# Kerrville LE- ADA Evaluation

**LE- Kerrville TX, ADA Evaluation**  
**309 Sidney Baker St S**  
**Kerrville, TX 78028**  
**Accessibility Evaluation**  
**Inspection Date: 03/06/2023**  
**Inspectors: Christopher Meza**

Report Date: 01/14/2024

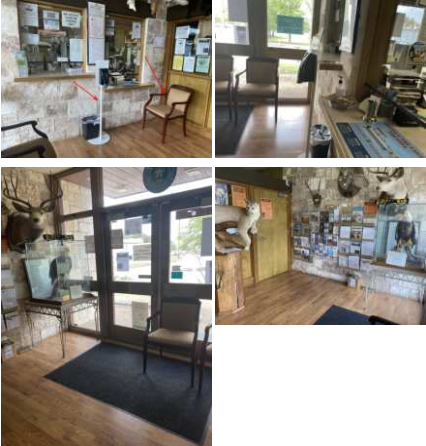
Finding Number	Area Description	Finding	As Built	Recommendation	Citation	Photos	Figure
8	Exterior of Property (Public): Path of Travel to Building - Path of Travel (Main Route)	The building entrance is not located on an accessible route. When a building, or portion of a building, is required to be accessible, an accessible route of travel shall be provided to all portions of the building, to accessible building entrances and between the building and the public way. At least one accessible route within the boundary of the site must be provided from public transportation stops, accessible parking and accessible passenger loading zones and public streets or sidewalks to the accessible building entrance they serve. The accessible route shall, to the maximum extent feasible, coincide with the route for the general public. At least one accessible route shall connect accessible buildings, facilities, elements and spaces that are on the same site. At least one accessible route shall connect accessible building or facility entrances with all accessible spaces and elements.	Due to rise, running slope, cross slope, and gaps in pathway, this route is not considered accessible. Ramp would need to be installed with compliant handrails.	<a href="https://www.access-board.gov/ada/#ada-206_2_1">https://www.access-board.gov/ada/#ada-206_2_1</a>	2012 TAS Section: 206.2.1  2010 ADAS Section: 206.2.1
